BVH ARCHITECTURE

ADDENDUM

ADDENDUM NO.: #01

PROJECT: Nebraska State Capitol Elevator Modernization For Elevator 8

9 ELEVATOR 8 ENTRY ELEVATIONS
 1/4" = 1'-0"

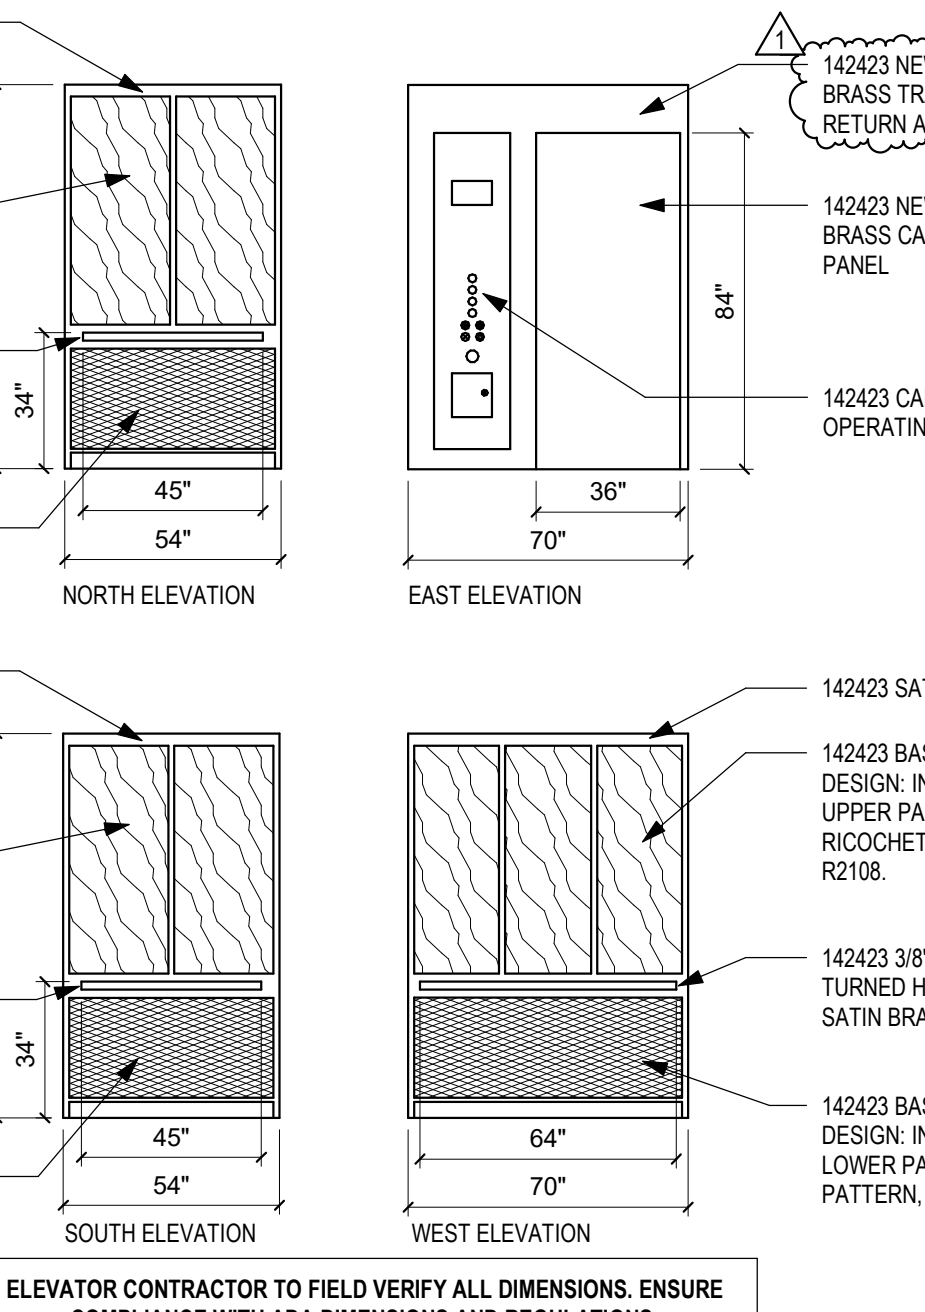
- d. 9 Elevator 8 Entry Elevations
 - i. The two-way communication device was removed from the first floor elevation.
 - ii. See updated elevation notes as clouded on the attached sheet.

3 ELEV. 8 BASEMENT ENLARGED DEMO PLAN
 1/4" = 1'-0"

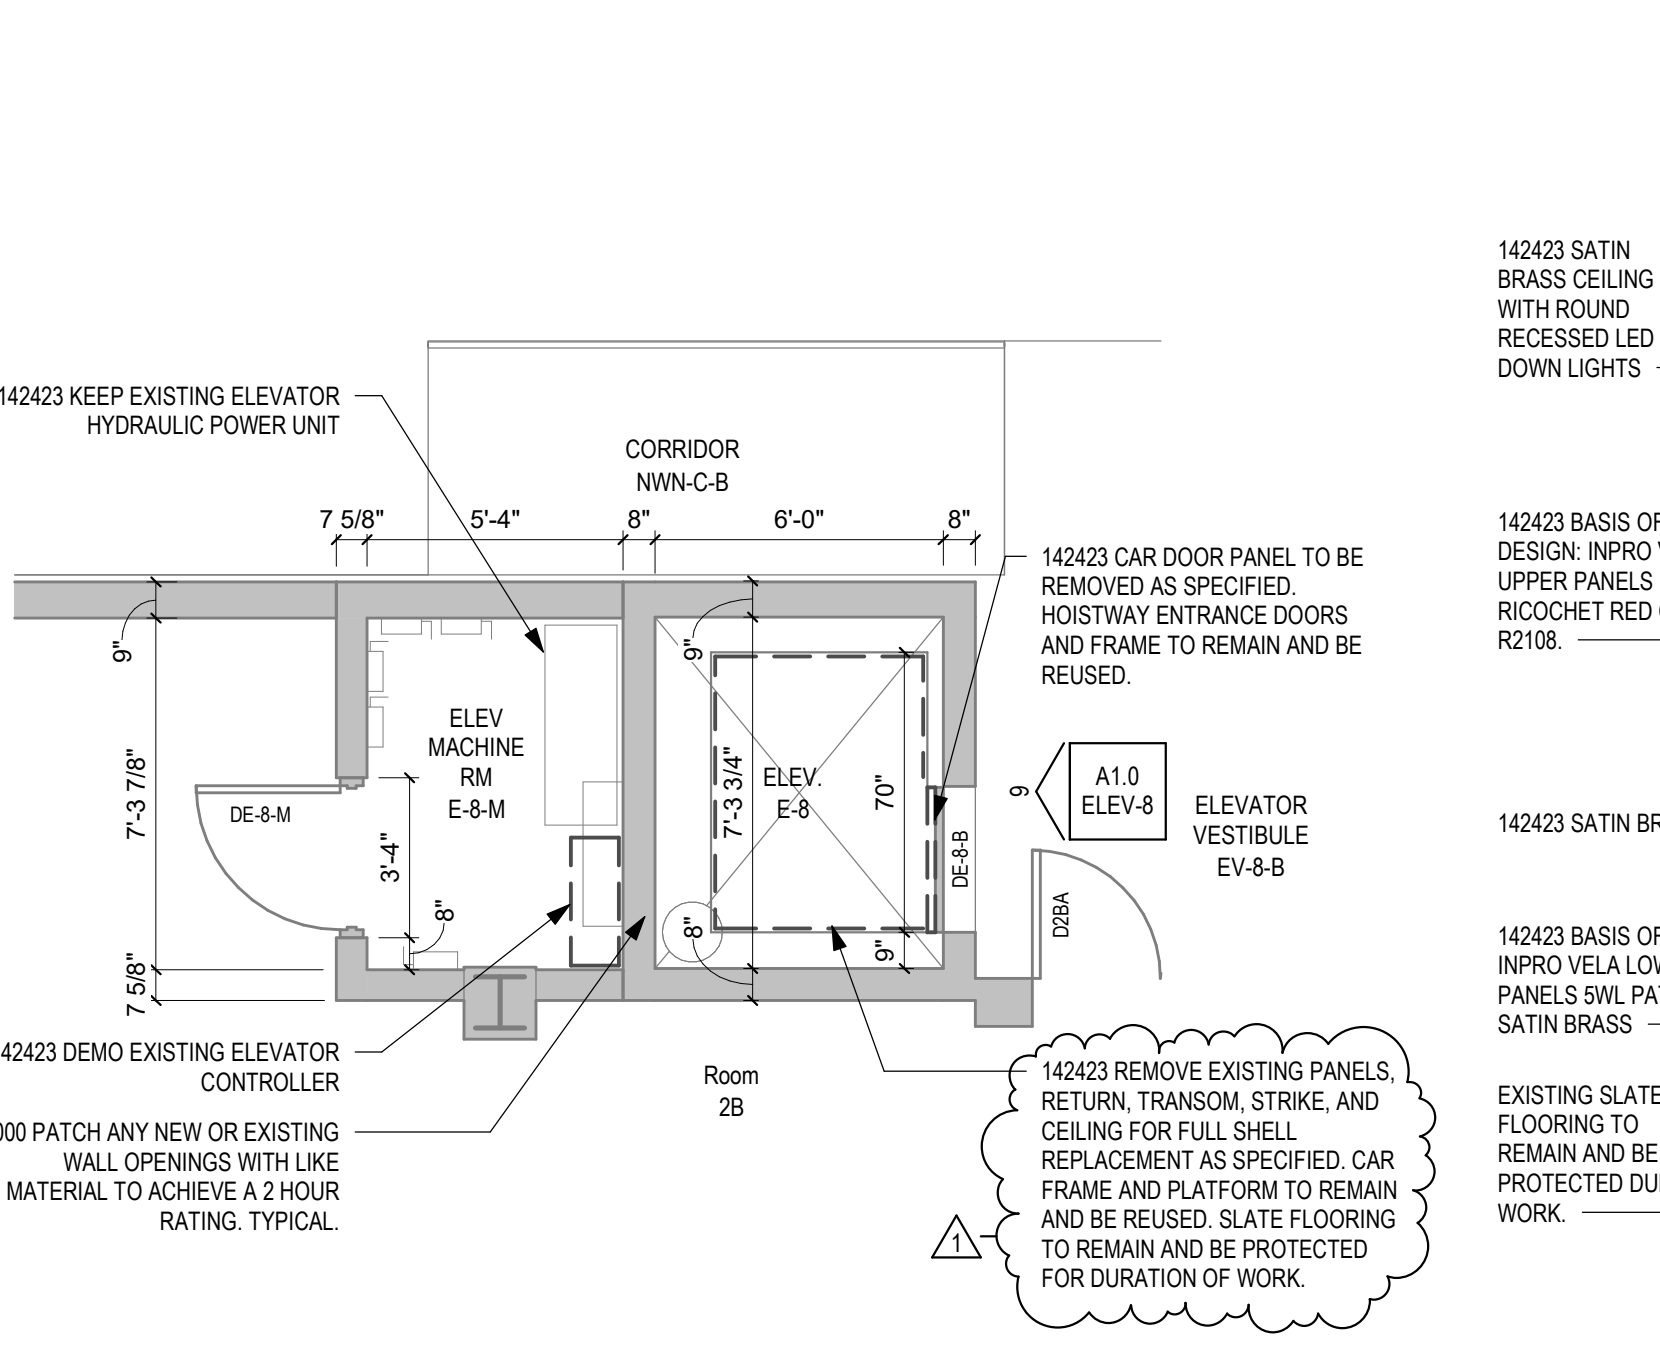
1. Sheet A1.0 ELEV-8; Enlarged Floor Plans And Sections
 - a. 3. Elev. 8 Basement Enlarged Demo Plan
 - i. See updated plan note as clouded on the attached drawing sheet.
 - b. 5. Elev. 8 Basement Enlarged Plan
 - i. See updated plan notes as clouded on the attached drawing sheet.
 - c. 12 Elevator 8 - Cab Interior Elevations
 - i. See updated East Elevation note as clouded on the attached drawing sheet.
